**BEFORE THE HEARING COMMISSIONERS FOR NORTHLAND REGIONAL  
COUNCIL**

of applications by Doug's Opuia Boatyard  
for discharge consents and coastal permits  
for activities ancillary to and associated  
with the boatyard on 1 Richardson Street,  
Opuia

**STATEMENT OF ANDREW JAMES MUNROE JOHNSON  
ON BEHALF OF DOUG'S OPUA BOATYARD (DOBY)**

## DOUG'S BOATYARD OPUA - REVIEW OF s42A REPORT AND EXPERT EVIDENCE

Figure 1 Subsurface Erosion Barrier supporting the shellfish bed

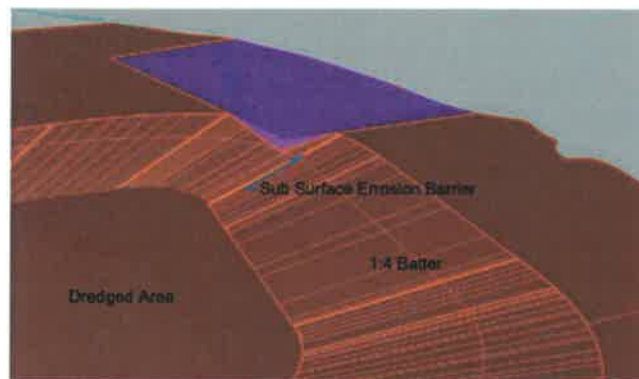
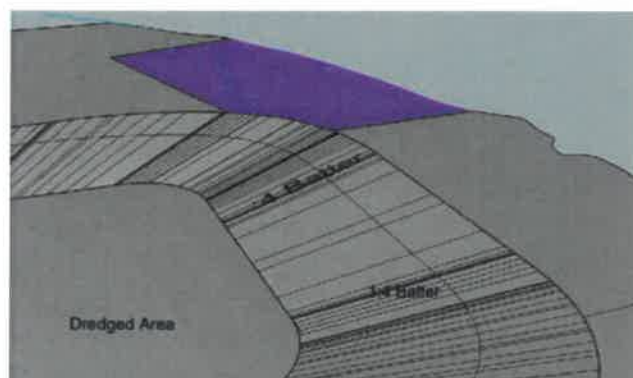
15. **Para 65** notes the purpose of the sub-surface erosion barrier, and **para 66** notes the NRC's preference for softer protection measures, including a shallow sloping batter with minimal modification to stable seabed levels. The paragraph continues:

However, if engineering advice can confirm that a subsurface erosion barrier is an appropriate and effective means of supporting the shellfish bed, with any alternative being impractical or having greater adverse effects on the environment, then it may be acceptable”.

The sub surface erosion barrier was proposed as a mitigating effect of the dredging on the shellfish bed. The primary purpose of the sub-surface erosion barrier is to stabilise the edge of the shellfish bed to prevent the batter extruding on the surface area of the shellfish bed. Either; (i) the sub-surface erosion barrier is used and shellfish bed remains largely undisturbed as illustrated in Figure 1, or (ii) the batter of the dredge pocket extends into the shellfish bed area as illustrated in Figure 2.

Either option is suitable to fulfil the operational requirements of the boatyard and achieve the required dredge depth, however with the subsurface erosion barrier the shellfish bed is not disturbed. In my opinion, the sub surface erosion barrier is less evasive than the batter into the shellfish bed.

Figure 1: Sub Surface Erosion Barrier shown supporting shellfish bed

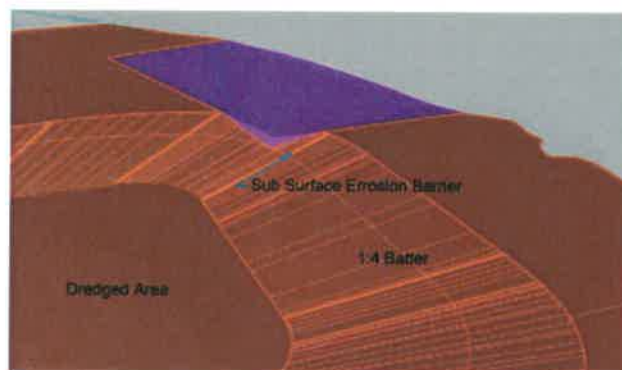
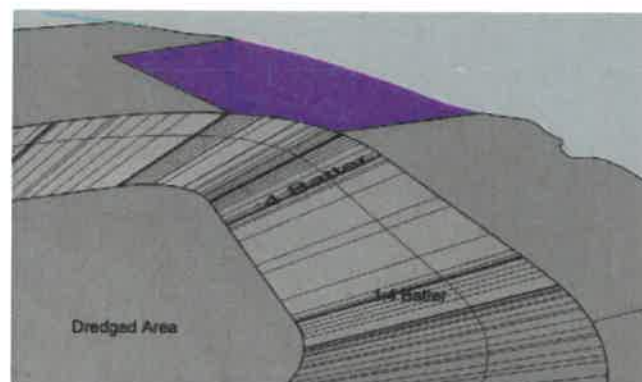
2. Paragraphs 72- 74 & Appendices 2 and 3 of the s42 report, conclude that the sub-surface erosion barrier shouldn't be included in the current consent application.

3. The sub surface erosion barrier was proposed as a mitigating effect of the dredging on the shellfish bed. The primary purpose of the sub-surface erosion barrier is to stabilise the edge of the shellfish bed to prevent the batter extruding on the surface area of the shellfish bed. For geotechnical stability reasons either; (i) the sub-surface erosion barrier is used and the shellfish bed remains largely undisturbed as illustrated in Figure 1, or (ii) the batter of the dredge pocket extends into the shellfish bed area as illustrated in Figure 2. Either option is suitable to fulfil the operational requirements of the boatyard and achieve the required dredge depth, however with the sub-surface erosion barrier the shellfish bed is not disturbed. In my opinion, the sub-surface erosion barrier is less invasive than extending the batter into shellfish bed.

4. A Sub Surface Erosion Barrier as a fixed structure is also intended to act as a groyne (refer to paragraph 5.3 of my initial Report) interrupting the longshore drift and encouraging material to be deposited on the up current side (on the shellfish bed) while causing erosion on the downstream side (slipway). This serves two useful functions by maintaining the shellfish bed and beach, while preventing material build-up on the ramp.

5. Thus, in my opinion a sub-surface erosion barrier is still the most suitable option to preserve the shellfish bed while fulfilling the operational requirements of the boat yard.

Figure 3: Security gate proposed location

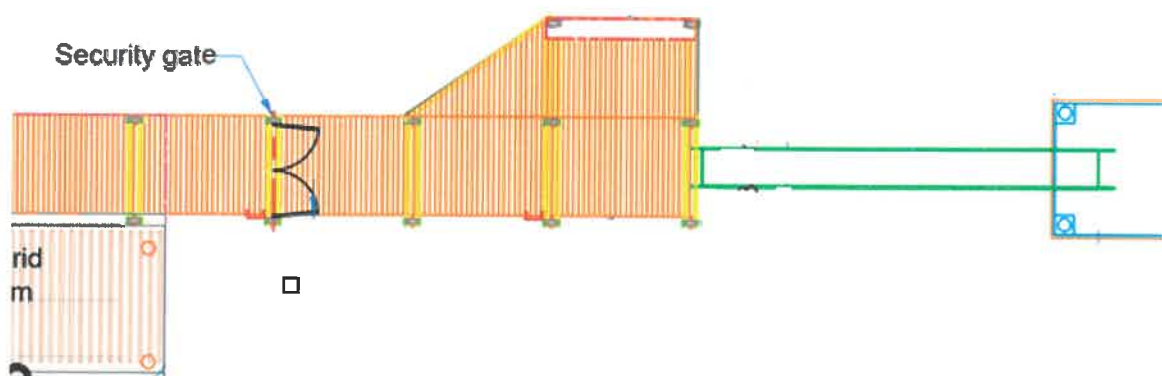
7. It has been proposed in the S42A report paragraph 40 that the security gate be moved to the end of the jetty at the head of the gangway in order to allow "full public access over the fixed jetty". I do not support that proposal. The boatyard has lifting equipment, storage and permanent berthage on the head of the fixed structure. As a consequence, this is a very hazardous environment and presents a significant H&S issue to the general public. A more suitable location for the security gate would be just before the T-head (as shown in Figure 3), as it still allows public access down the wharf and small boat access but prevents any assess to the hazardous areas.
